MEMORANDUM

Project: Project No. 2019035, 26-34 South First Street – San José, California Consulting

Re: Review for conformance with the Secretary of the Interior’s Standards for the Treatment of Historic Properties for Rehabilitating Historic Buildings
Review for conformance with the Downtown San José Historic District Guidelines (2003)
Review for conformance with the Draft Downtown Historic Design Guidelines (2004)
Review for conformance with the San José Downtown Design Guidelines and Standards (2019)

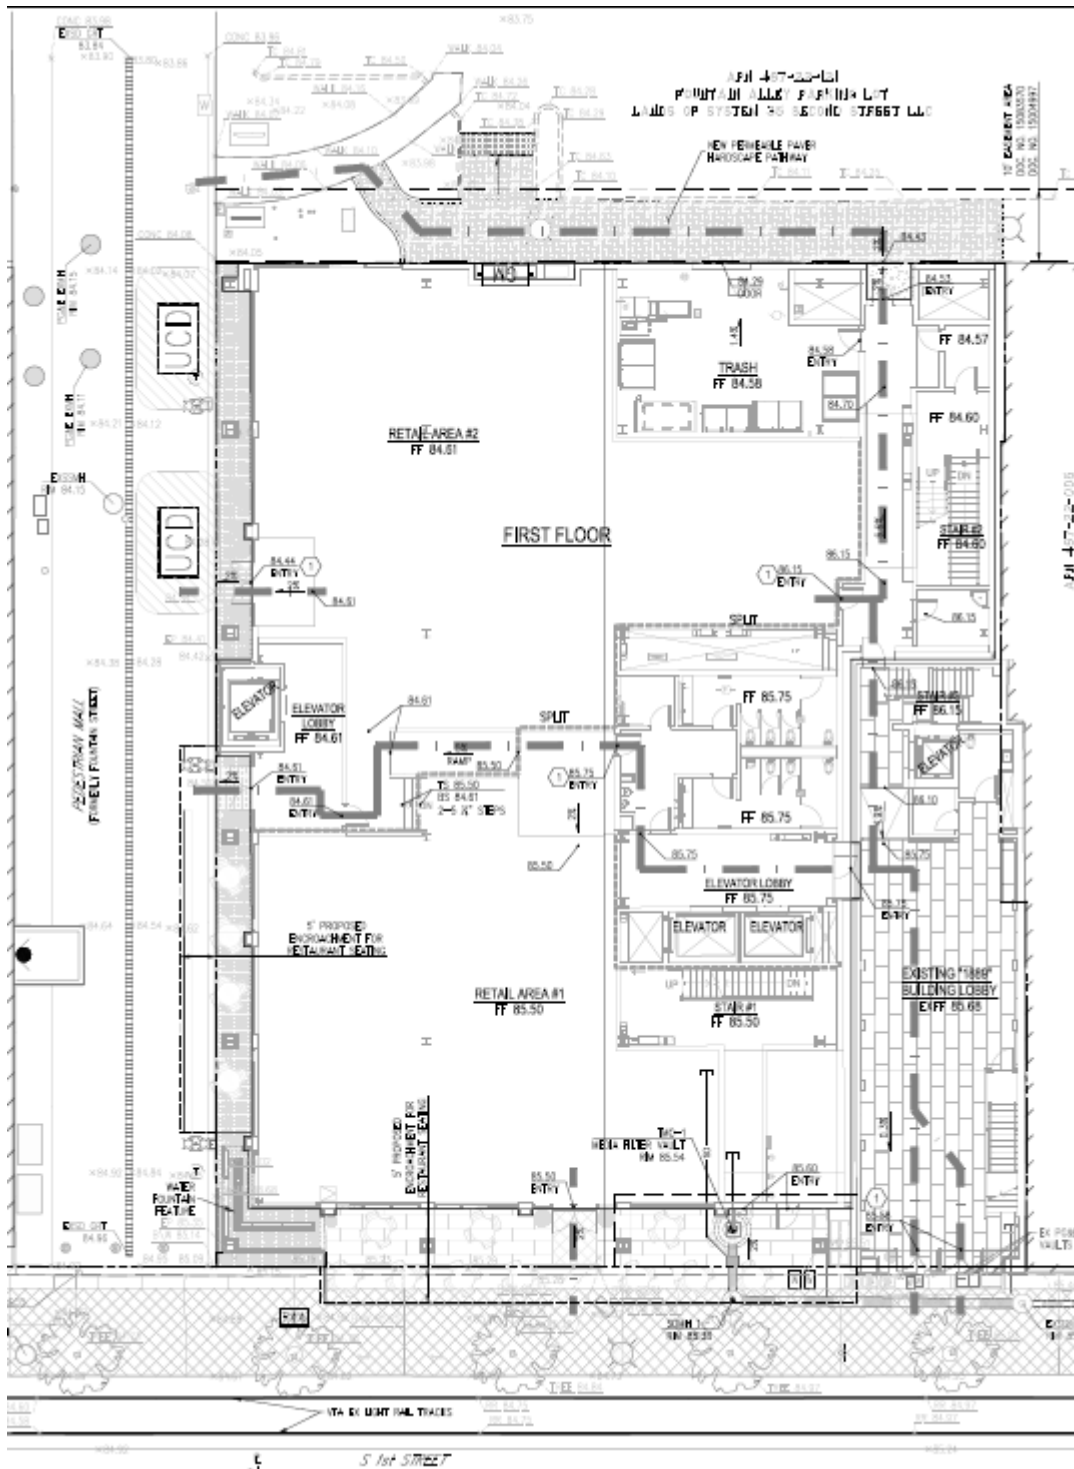
The stucco soffit at the transition between the second and third floor brings the building façade in line with the Knox-Goodrich building. Horizontal metal panels indicate transitions between the subsequent floors. Large two-panel windows fill the spaces between the metal panels and the vertical brick. The fourth set of bays have three-part windows and X-bracing on the third through sixth floor. The two sixth floor southern bays are notched back where the building is adjacent to and wraps around the Knox Building. The material on the notched back portion of the sixth floor transitions from flat brick to light colored plaster. A glass wind breaker tops the sixth-floor cornice to accommodate a roof terrace.

The Fountain Alley-facing façade is similar to the South First Street façade. It features the same materials, fenestration and spatial proportions as the primary façade. However light-colored plaster cladding is used in lieu of flat brick cladding after the first two bays of floors three to six. An elevator shaft is glazed and has X-bracing flanked by metal panels. The first two floors are recessed to provide for additional outdoor

The first and second floor on both Fountain Alley and South First Street are recessed by approximately eight feet from the lot line. A soffit at the second-third floor transition brings the façade back to the lot line. Columns in front of the first and second floors visually bring the façade to the property line. The two southern bays of the sixth floor facing South First Street are stepped back, apparently to soften the roofline transition between the proposed building and the Knox-Goodrich building and the rest of the South First Street block. The revised design no longer conforms with this guideline.
